**Evaluation of South Texas Project Electric
Generating Station Units 1 And 2 Offsite Dose
Calculation Manual, Revision 6**

**Docket No. 50-498, Facility License No. NPF-76
Docket No. 50-499, Facility License No. NPF-80**

Technical Evaluation Report For The Evaluation Of South Texas Units 1 And 2 ODCM

Figure 1. STP liquid radwaste pathways.

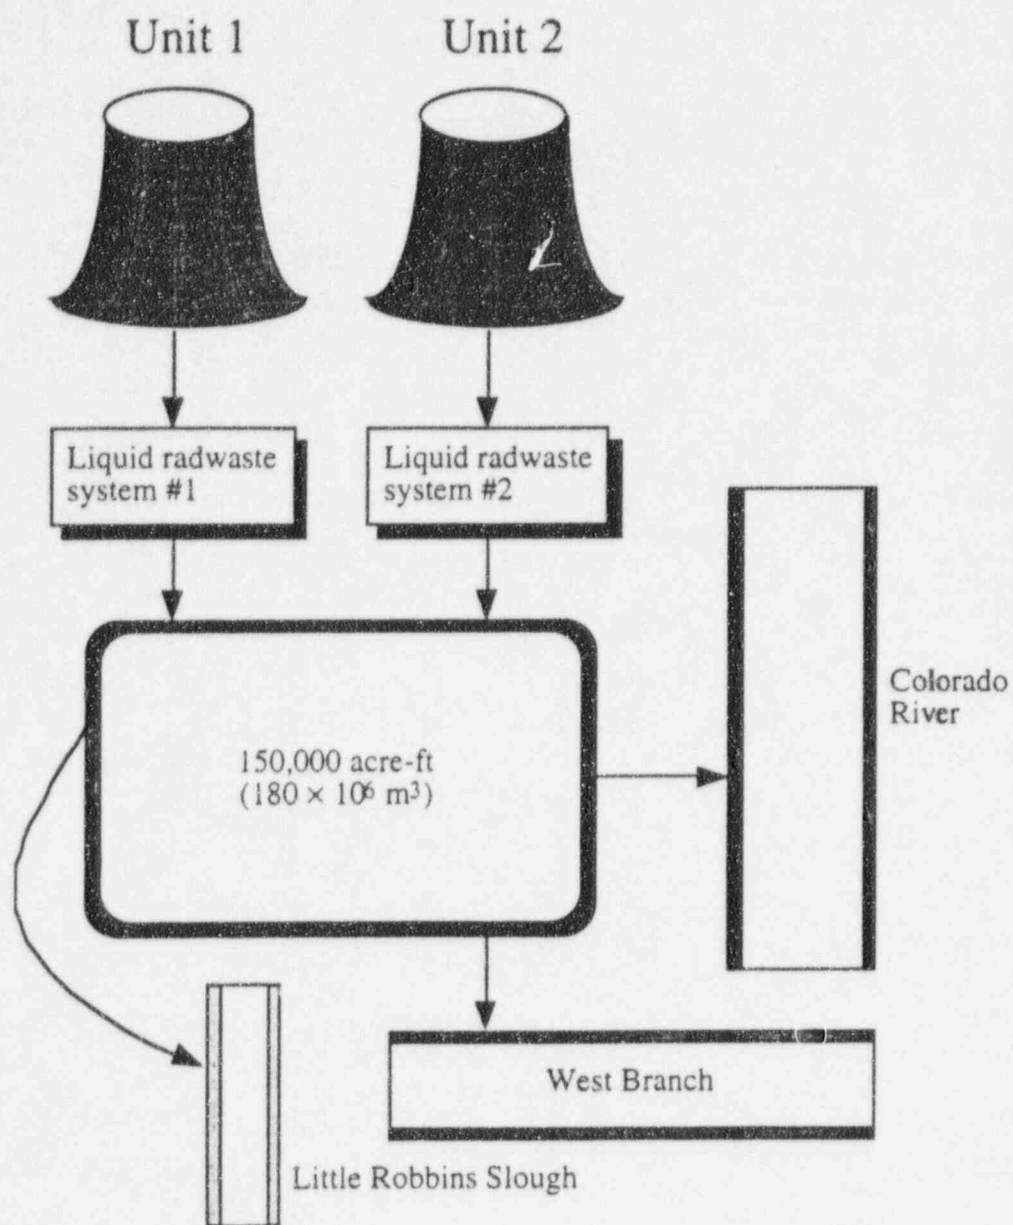
The STP ODCM does not contain any diagrams of the liquid effluent release points, flow paths, and alarm locations. One or more simple figures should be included that illustrate the liquid effluent pathways. Also, it is recommended that diagrams of the liquid radwaste effluent system and other relevant systems be included in the ODCM. Detector locations should be included in these figures. The form of the suggested figures is shown in Figure 1 although sufficient detail is not shown in this figure.

The STP ODCM contains two diagrams related to radioactive effluent treatment and release routes. Diagrams are included only for the gaseous effluent release points. It is recommended that graphical representations of the liquid effluent release points, paths and alarm locations be made. In addition, it is suggested that the gaseous effluent diagrams be revised as they are difficult to read, rely on unexplained abbreviations, and are not very detailed. The Branch Technical Position⁸ states that the ODCM should contain "simplified flow diagrams defining the treatment paths and the components of the radioactive liquid and gaseous waste management systems." The licensee should replace the present figures with appropriate simplified flow diagrams.

Figure 2. Primary gaseous effluent release routes at STP. (Based on Figure B2-1 of the STP ODCM Revision 8.)

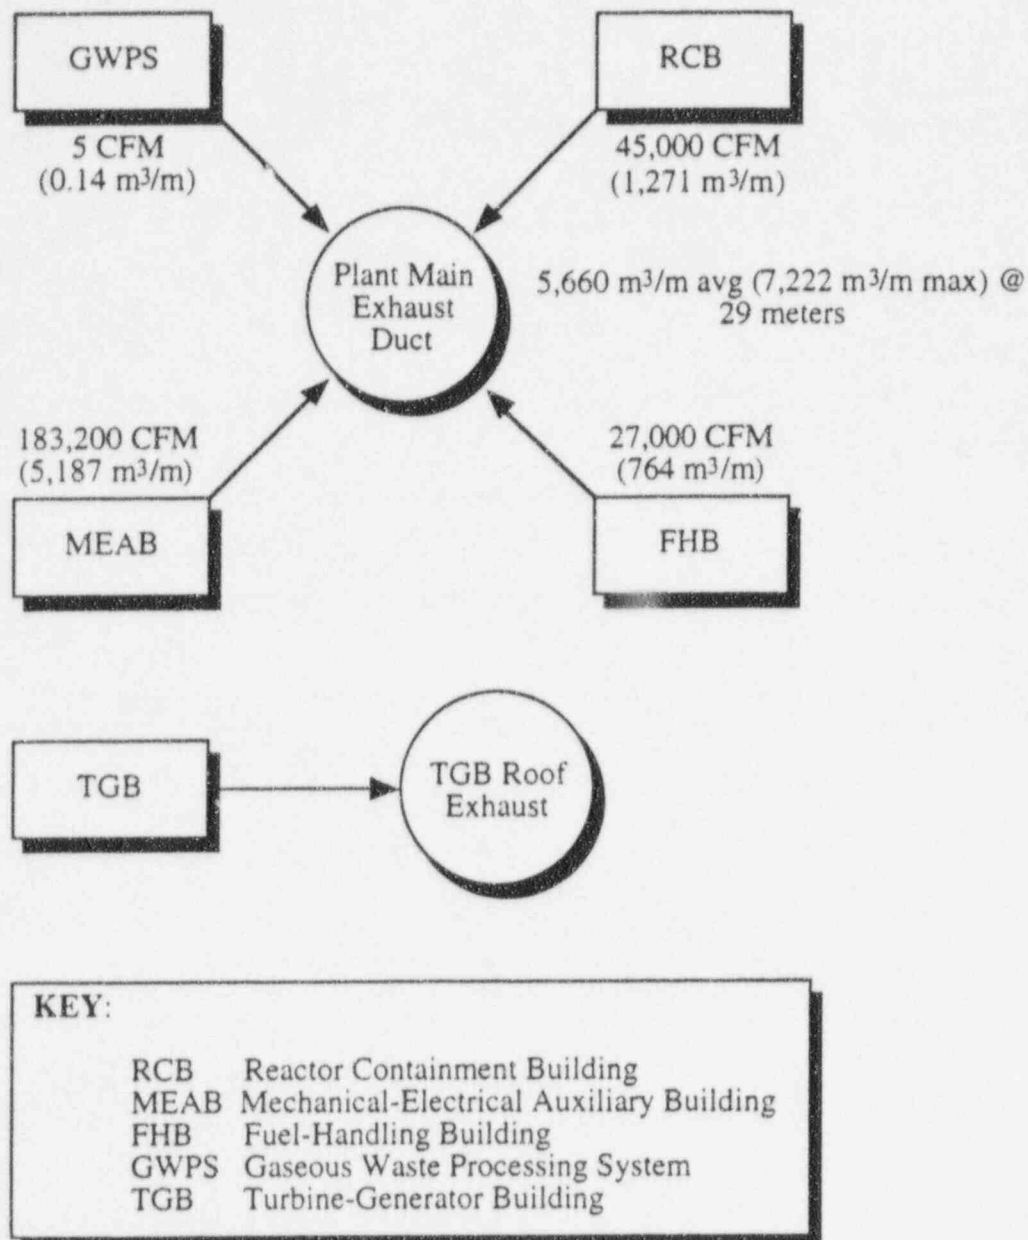
Only the first four sources contribute significantly to routine plant atmospheric releases. The effluents from the first four sources are routed to a common exhaust pipe located on the roof of each unit's MEAB. The Turbine-Generating Building has its own exhaust pipe located on its roof. Figure 2 illustrates the five radioactive gaseous discharge points, and Figure 3 illustrates the Turbine-Generator Building Exhaust. In Figure 2, the sum of the release rates is about 7,000 m³/min; however, in Section 2, it states that the average flow rate is 5,600 m³/min. Maximum flowrates for different operational modes should be defined in the ODCM.

In Table 3.3-13, a monitor for the vent is identified. The condenser evacuation system effluent, which was monitored, has been rerouted to the vent for one reactor and is in the process of being rerouted to the unit vent for the other reactor. It should be made clear in the ODCM that there is a unit vent monitor for each unit. Also, ODCM Figure B2-1, Unit Ventilation Systems, is missing the gaseous waste processing system and Turbine-Generation Building gaseous release pathways. This information should be included in one or more diagrams that illustrate the gaseous release pathways.

For gaseous releases, the height of the release points should be specified in the ODCM. Additionally, vent sizes, exit velocities, and/or flowrates should be specified along with the height of surrounding buildings. Dose calculations are dependent on the height of the release point.

1. In Table 3.3-13, a monitor for each unit vent is identified; however, it should be made clear that there is a unit vent monitor for each unit. Also, ODCM Figure B2-1, unit ventilation systems, is missing the gaseous waste processing system and Turbine-Generation Building gaseous release paths. This information should be included in one or more diagrams that illustrate the gaseous release paths.
